EVALUATION AND RECOMMENDATIONS FOR RIVER BANK PROTECTION AT FARIDPUR DISTRICT TOWN – PADMA RIVER

MISSION REPORT

DECEMBER 2005

Subject : Final Report Technical Mission Evaluation and Recommendations for river bank protection at Faridpur District Padma River - Bangladesh

Fig A6-1 (Figure No. A2)

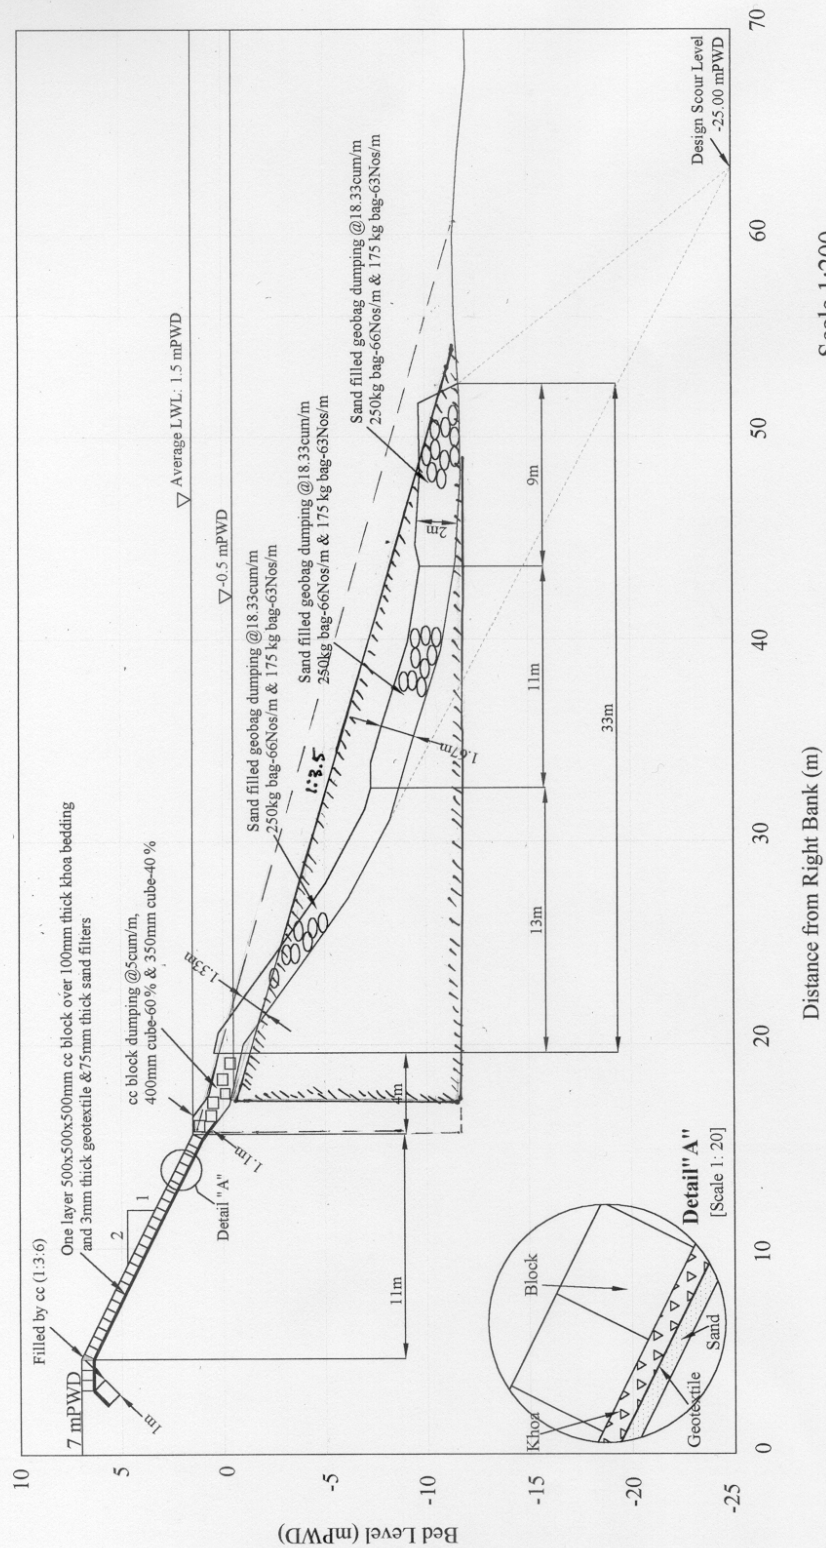
It can be argued that the new design as now proposed is more expensive than the existing design for Faridpur Town Protection⁶. This is checked by calculating quantities for the typical section at Farid-63 (Fig. A2 in Technical Note, copied in this Mission Report as Figure A6-1).

- 1 It has nowhere been demonstrated that such large geo-bags have to be used as proposed in the Technical Note. The Mission recommends using only one type of bag, i.e the one having a dry weight of 78 kg at 100 % fill.
- 2 Filling of the transition zone ('cheap' fill as well as cover layer) should start from the river side working towards the bank. This is proposed to avoid slides.
- 3 Filling of the falling apron should start from the landward side. This is to avoid formation of gullies between (partially completed) falling apron and the transition zone.
- 4 It is felt that a careful construction of the revetment without large protrusions under water could significantly reduce the design scour depth to be used for calculations.

Figure A6-1 Proposed modification with underwater slope 1: 3.5, new design.
